# Work Order ID 122769

Item ID: D206-667-203 Accept **\*N900040100\*** Setup Start **\*NS1\***  
 Revision ID: Stop **\*NS2\***  
 Item Name: Aft Crosstube - High 206L / L1 / L3 / L4  
 Start Date: 7/23/14 Start Qty: 1.00 **\*1\*** Cust Item ID:  
 Required Date: 7/23/14 Req'd Qty: 1.00 **\*1\*** Customer:  
 Reference:

| DRAWING NO.<br>D206-667-243 | TITLE<br>CROSSTUBE ASS'Y (206L HIGH AFT) | REV. C           | DART AEROSPACE LTD<br>ENGINEERING ORDER |  | D.E.O. NO.<br>D206-667-243-C-1 | SHEET NO.<br>SHEET 1 OF 1 | SCALE<br>NTS |

| DE APPR.   |  | SUPPORT INSTALLATION CHANGE   | NTS          |

DETAIL L: CROSSTUBE CUFF  
NOT TO SCALE

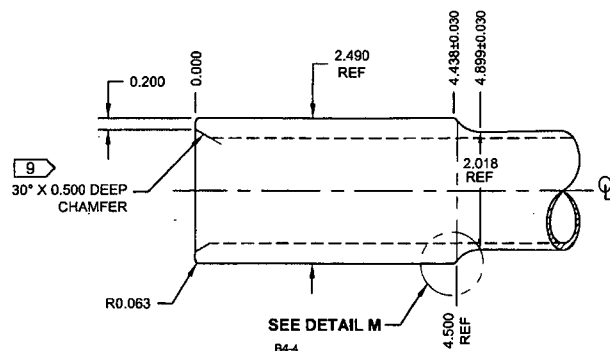
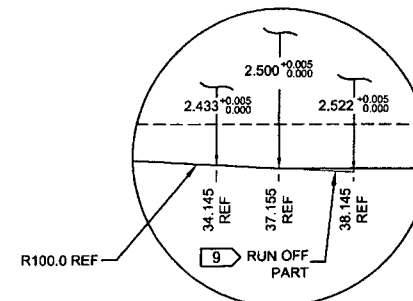
UNDER REVIEW

DEO ATTACHED

NOTE 12 & 15, SHEET 1 IS AMENDED AS FOLLOWS:

- 12) TO INSTALL D2892-1 SUPPORT: ABRASE MATING SURFACE OF SUPPORT AND CROSSTUBE WITH 180-GRIT SANDPAPER AND REMOVE RESIDUE WITH MEK (OR EQUIVALENT). APPLY A 0.04" TO 0.07" THICK LAYER OF PROSEAL 890 CLASS B-2 (OR AMS-S-8802 CLASS B-2) SEALANT TO MATING SURFACE OF SUPPORT.
- 15) TORQUE CLAMPS 80 TO 100 IN-LB. ENSURE AT LEAST 1.5 THREADS SHOWING IN SAFETY AND THAT NUT HAS NOT BOTTOMED-OUT AFTER TORQUING. **PRIOR TO PACKAGING, RE-CHECK TORQUE ON CLAMPS AFTER PROSEAL 890 SEALANT HAS CURED FOR 72 HOURS.**
